**STAFF REPORT
(ADDENDUM)**

CASE NUMBER: P.D. 08-324 CC **L.U.C.B. MEETING:** December 11, 2008
Held from November 13, 2008

DEVELOPMENT: WOODLAND HILLS II PLANNED DEVELOPMENT, AMENDED

REQUEST: Planned development amendment to allow single family homes with minimum lot sizes of 6,000 sq. ft., including independent and assisted living for seniors, licensed health care, nursing home and associated medical facilities.

OUTLINE PLAN-REVISED

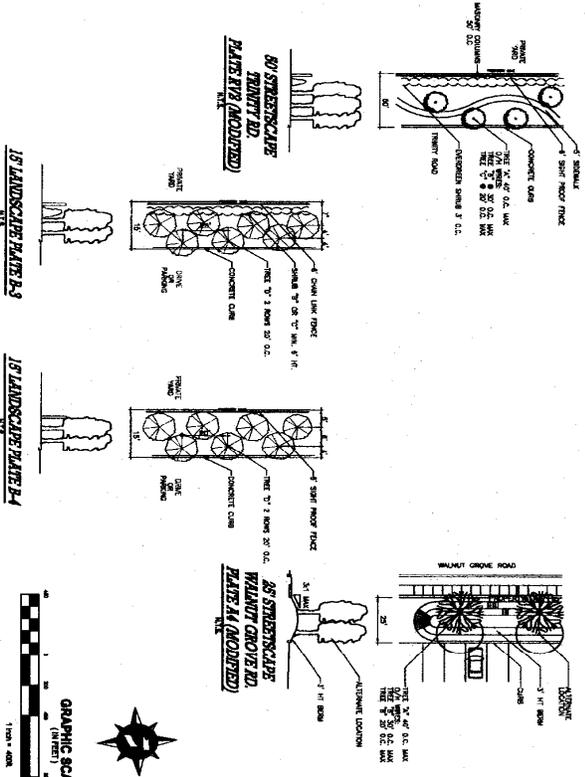
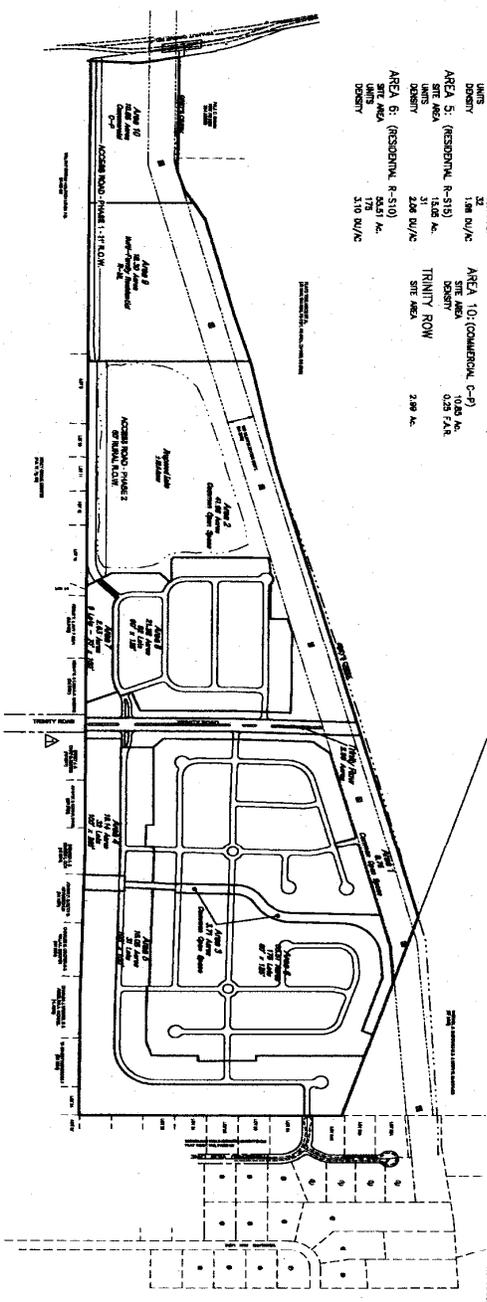
On November 13, 2008, the applicant requested and the Land Use Control Board granted a hold of this application for thirty(30) days in order for the applicant to consult with staff regarding a public road connection from Trinity Road to Walnut Grove Road at the south end of the subject property. The project was also held to allow further clarification of alternative land uses in Areas 6A-Alt, 7, 8-Alt and 9-Alt and the inter-connectivity as each phase develops. The development of 6,000 square foot lots proposed in these Areas of the Outline Plan will only develop as private gated senior living single family homes. Otherwise, the development will remain as it was originally approved, but with the following public road connection.

The applicant has submitted and agreed to a revised Outline Plan that provides a public road through the development and provides inter-connection between Walnut Grove Road to the south and the existing street system tying into Woodland View Lane. A condition is attached that requires the dedication and improvement of a thirty-one(31') foot wide alternative design roadway, except adjacent to the lake in Area 2 where it may be a rural cross-section road. However, the proposed alternative pedestrian walkway system should run the entire length of the proposed public road to maintain a walkable senior community. This pedestrian walkway system, including the public road shall also be illustrated on the Outline Plan and recorded. The alignment of this roadway may shift eastward onto the Canale Grove Planned Development; however, a compromise has not been agreed upon regarding the location of this public roadway nor the inter-connection of a public roadway system.

FIGURE-2
2017 CONGESTED CORRIDORS MAP:

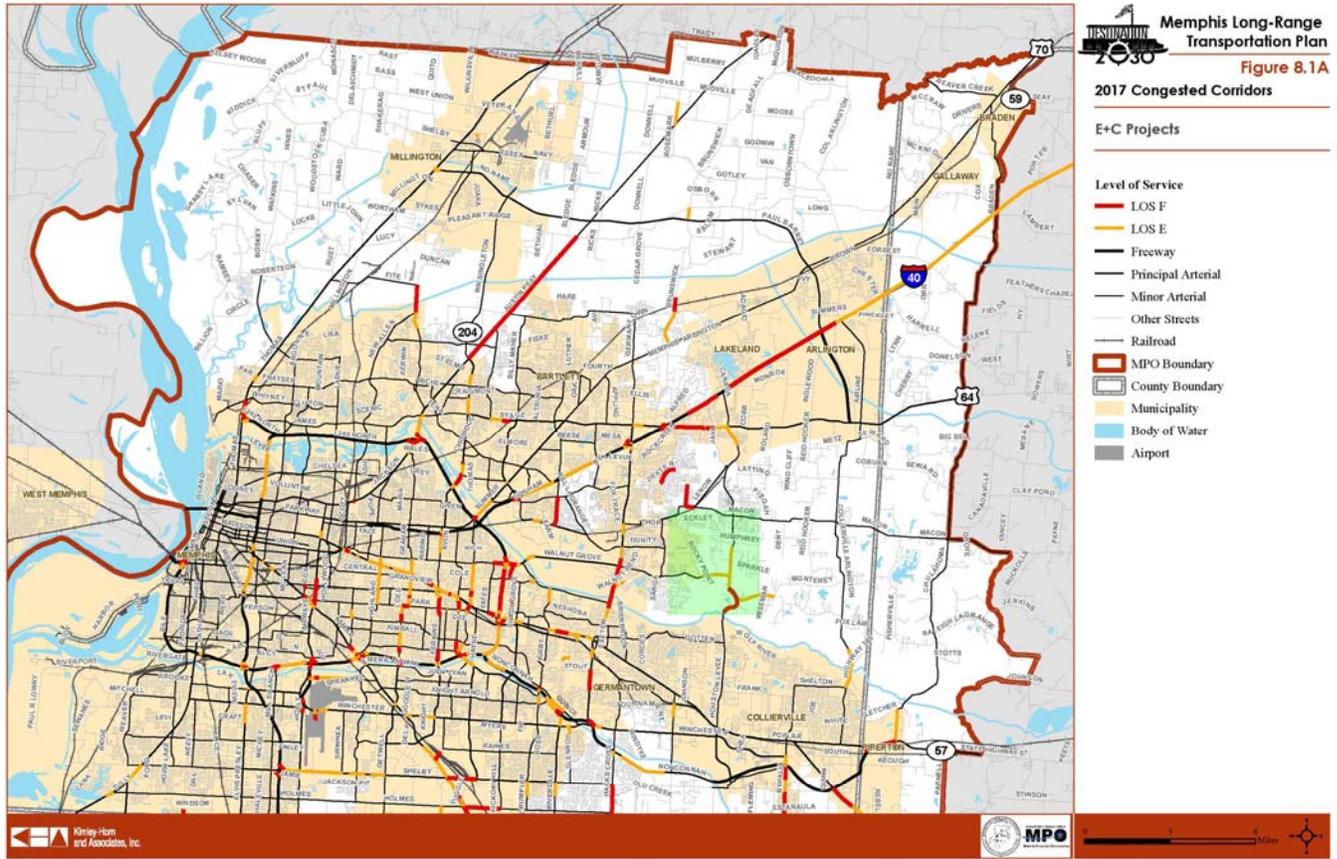
The Division of Planning & Development **Transportation Planning** section has projected a worst congestion scenario for Walnut Grove and Houston Levee roads in the future.(See **Figure 2-Page 6**) They are concerned that the size of proposed developments at this intersection will create further traffic congestion and that eliminating the north-south route will exacerbate this problem. The full text of their comments are included on **Page 29** of this Staff Report.

See Figure 2, Congested Corridors Map-Page 6 for our 2030 LRTP that shows the congested network fro 2017 (We have highlighted the Study Area).

CONCEPT PLAN:

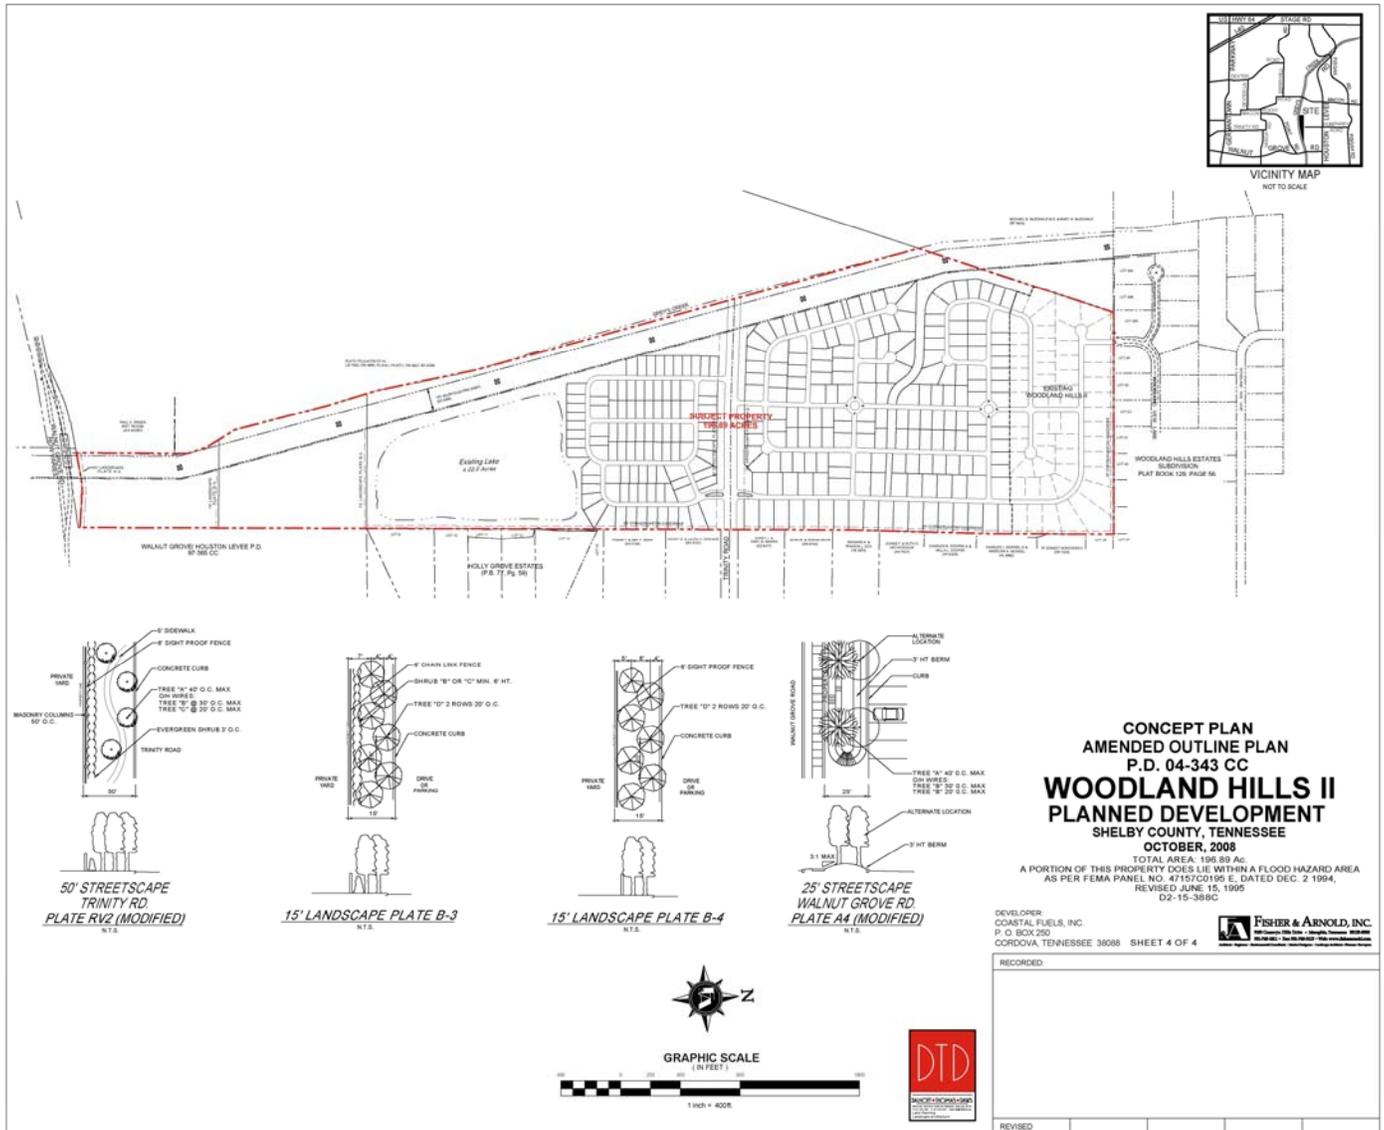
The planned development amendment application seeks to increase the density of the overall development plan from 3.8 dwellings units per acre to 4.43 units per acre. This calculation includes the development of Area 9 for multi-family and not cottages or the senior health center. This amendment to allow lots 6,000 square feet in area is significantly greater than recommended density in the Gray's Creek Area Plan which recommends one(1) dwelling unit per acre with sanitary sewer. Therefore, this proposal for smaller lot development does not conform to the recommended density of the Gray's Creek Area Plan. Furthermore, the street layout and design for single family in the Outline Plan does not coincide with the Concept Plan submitted by the applicant.

All public planning agencies concerned about transportation planning and have recommended that the north-south road connecting Trinity Road and Walnut Grove Road remain in place. The **County Engineer** states: "The Concept Plan road layout is not recommended. A network of public streets is preferred. A collector street to Walnut Grove is recommended." The **City Engineer** recommends rejection of the request to delete any of the public roads within this site—see comments on **Pages 23-27** of this report for more details on their concerns regarding the elimination of this north-south road and the resulting added congestion at Walnut Grove and Houston Levee roads intersection.

3. The concept plan road layout is not recommended. A network of interconnecting streets is preferred. Specifically;
 - A 3rd point of access is required for the planned development. A collector street to Walnut Grove Road is recommended. It should be built with the first phase of development. All construction traffic should be directed to this road.
